PAINT BRUSH HILLS FILING NO. 13E
CONSTRUCTION PLANS
KEY MAP WITH SIDEWALK LOCATIONS
INCLUDING TYPICAL ROAD SECTIONS

PAINT BRUSH HILLS FILING 13E
CONSTRUCTION PLANS
STREET IMPROVEMENT PLANS
KEATING DRIVE

PAINT BRUSH HILLS FILING NO. 13E CONSTRUCTION PLANS STORM SEWER PLAN

PAINT BRUSH HILLS FILING 13A
CONSTRUCTION PLANS
DETENTION FACILITY D
OUTLET BOX DETAILS

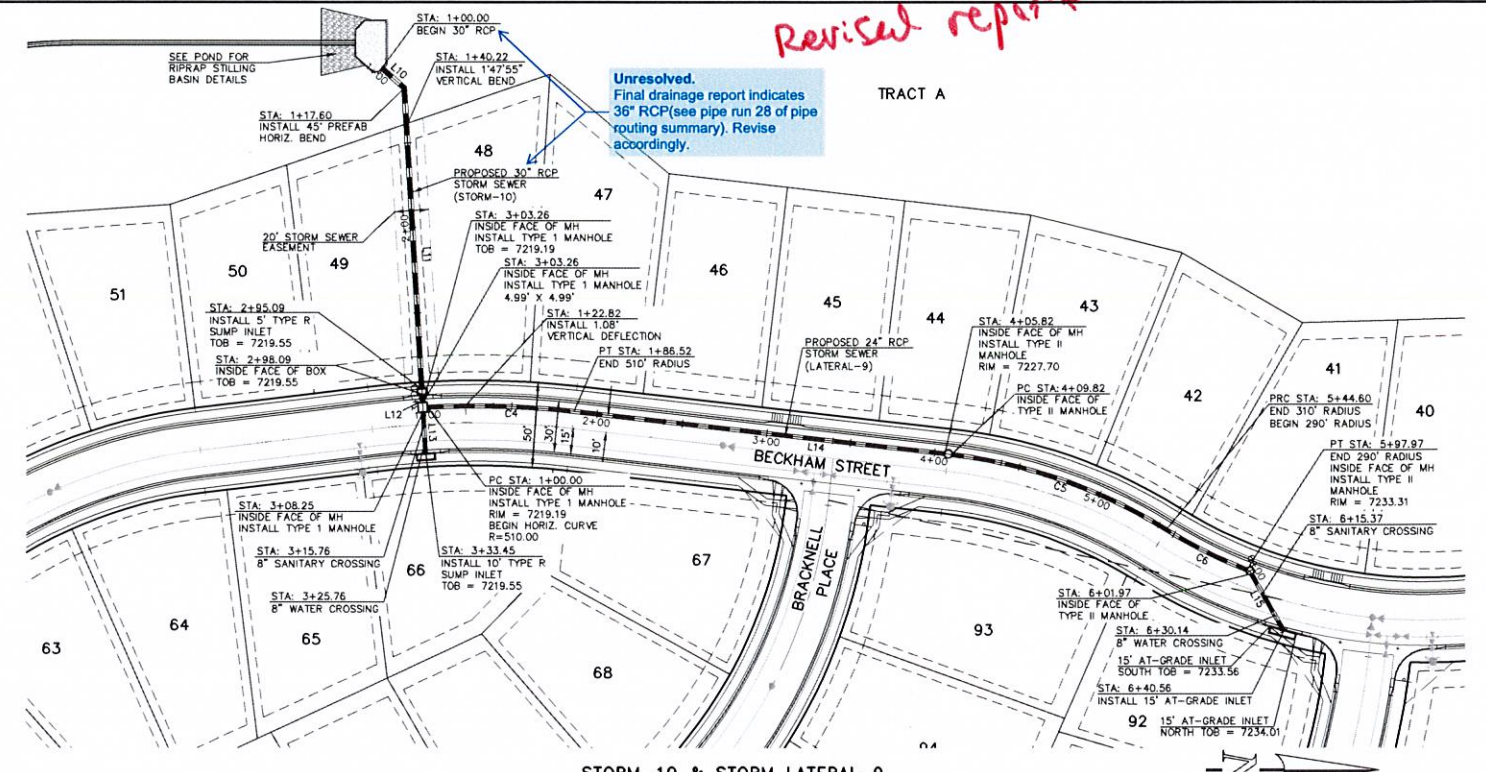
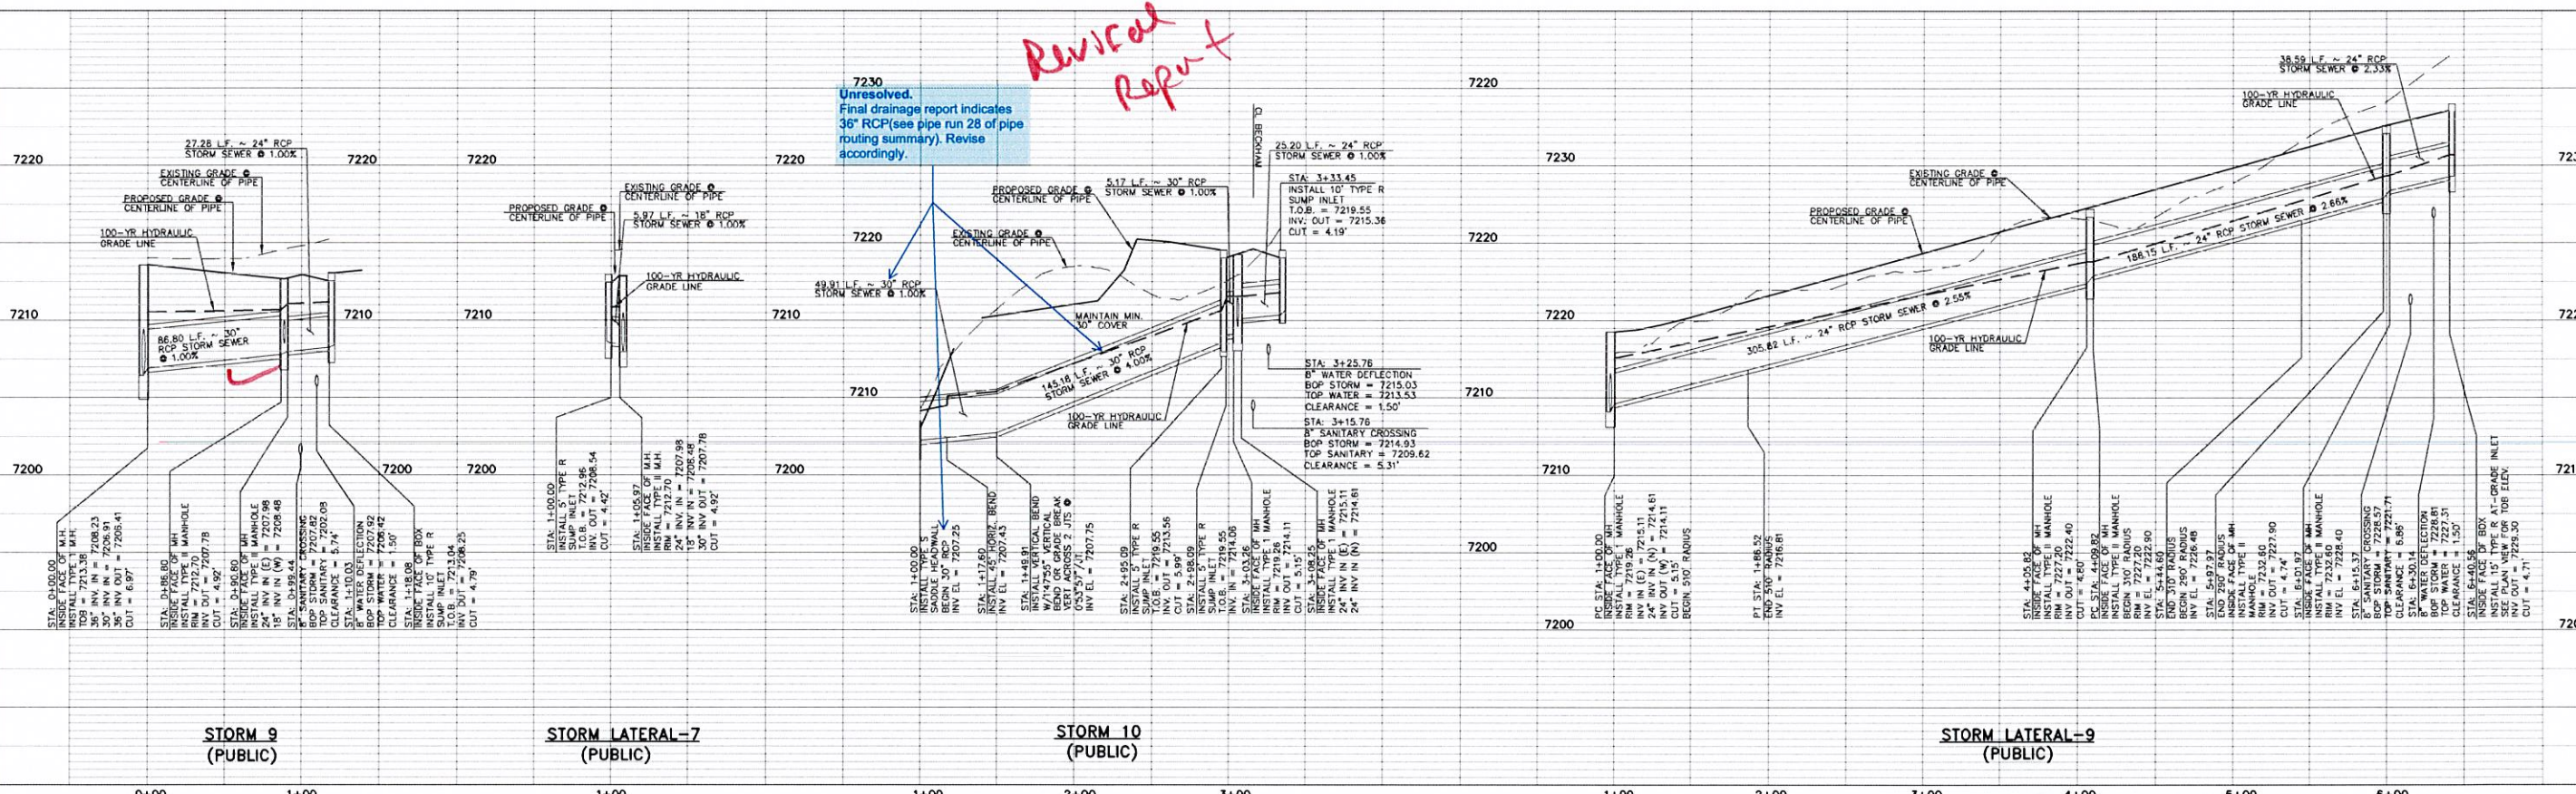
Profile below and drainage report indicate 30" RCP

Unresolved. Final drainage report indicates 36" RCP (see pipe run 28 of pipe routing summary). Revise accordingly.

Unresolved. Final drainage report indicates 36" RCP (see pipe run 28 of pipe routing summary). Revise accordingly.

Revised report

changed ~~that~~ to 30" upgraded to 30" due to HGL's

Revised Report

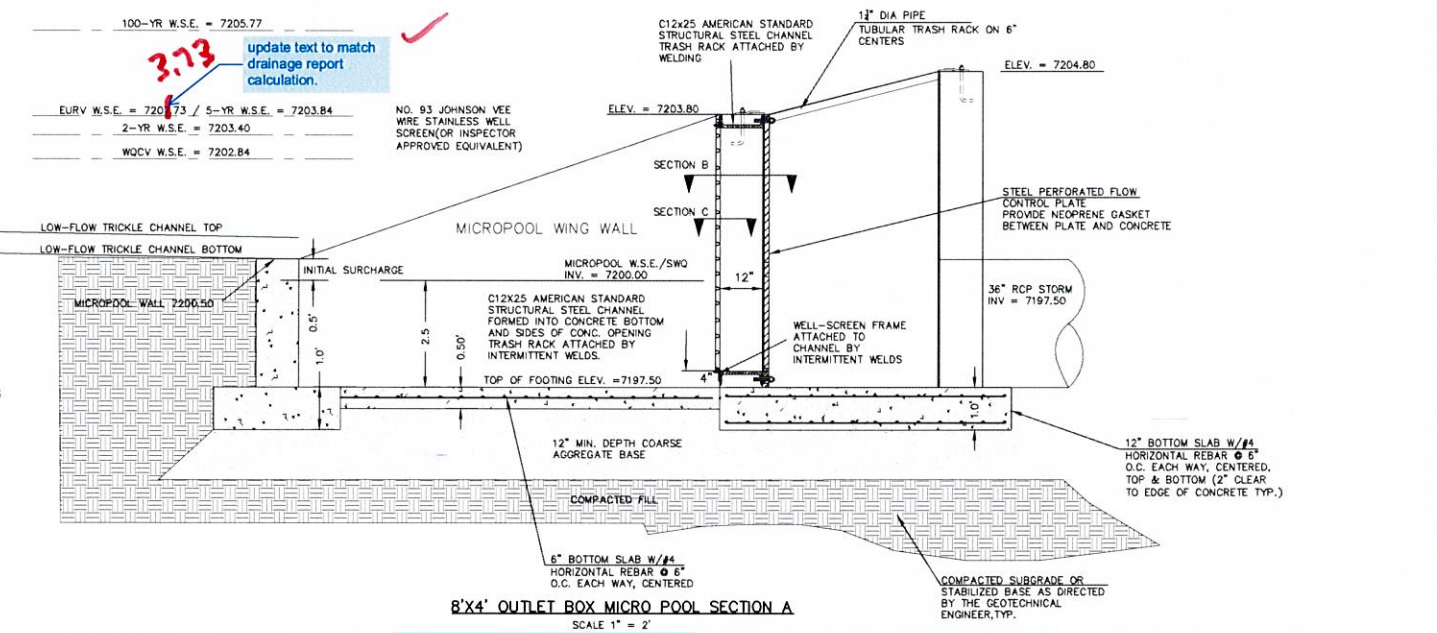
update text to match drainage report calculation.
